GRADING PLAN "AS BUILT" INFORMATION

NETHERWOOD VILLAGE

GRADING PLAN

**NETHERWOOD VILLAGE
 PHASING PLAN**

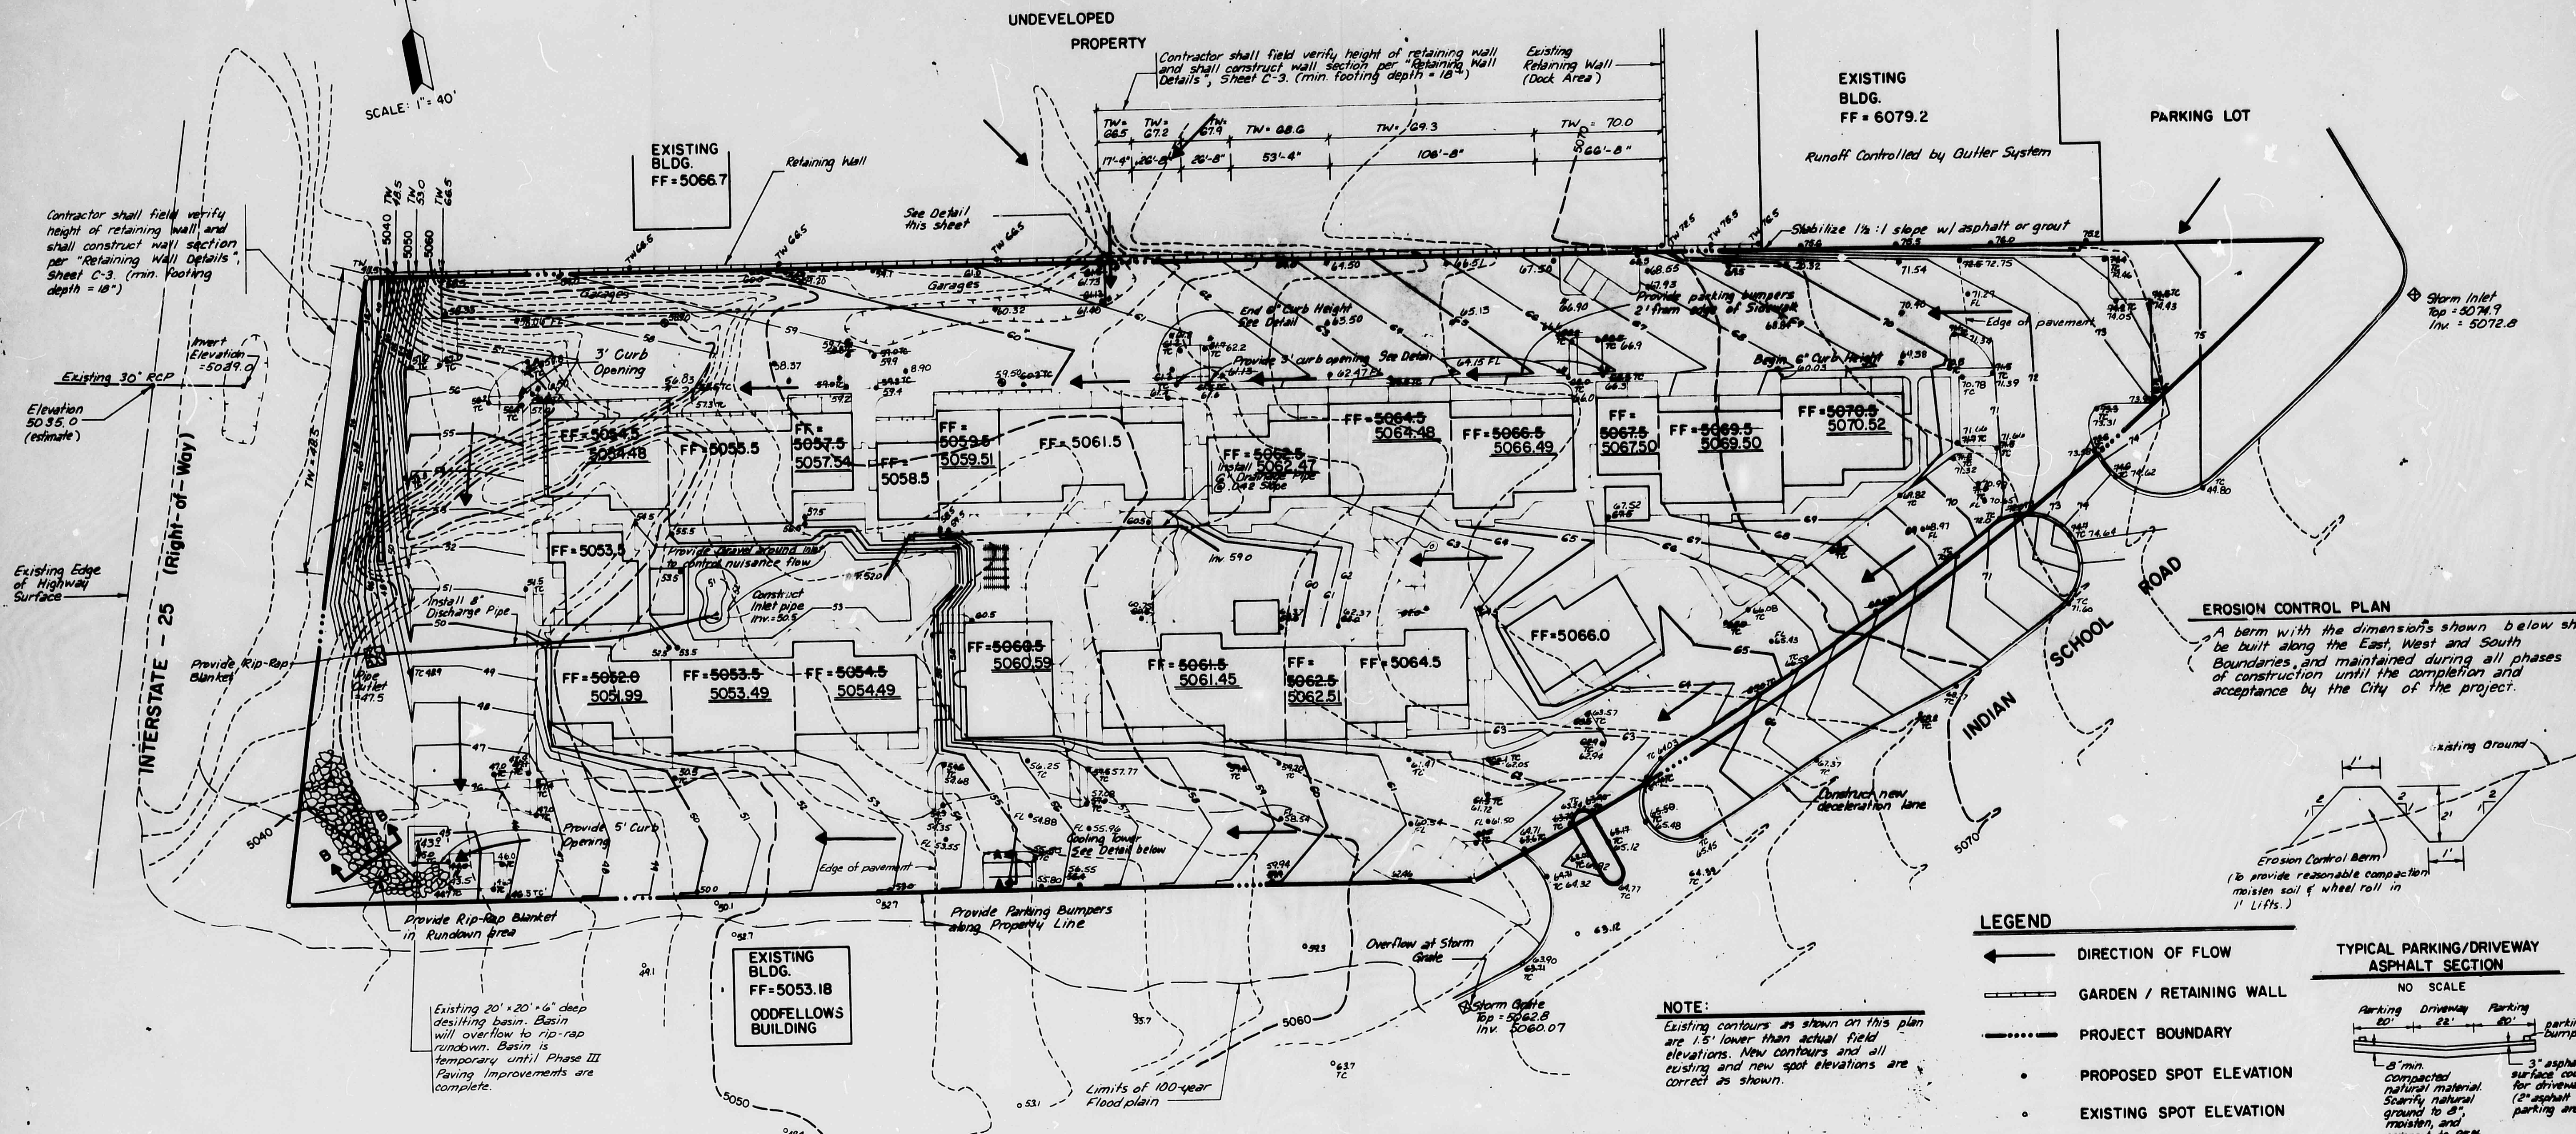
"As Built" Notes:

- 1) Onsite TC elevations have been determined by adding 0.5' to asbuilt flowline elevations.
- 2) Currently, Phase I and 2 has been paved.

This grading plan is a revised and corrected version of the original plan, approved 5/17/84. An error in the project TBM elevation necessitated revisions to the plan. No grading or drainage patterns have been altered.
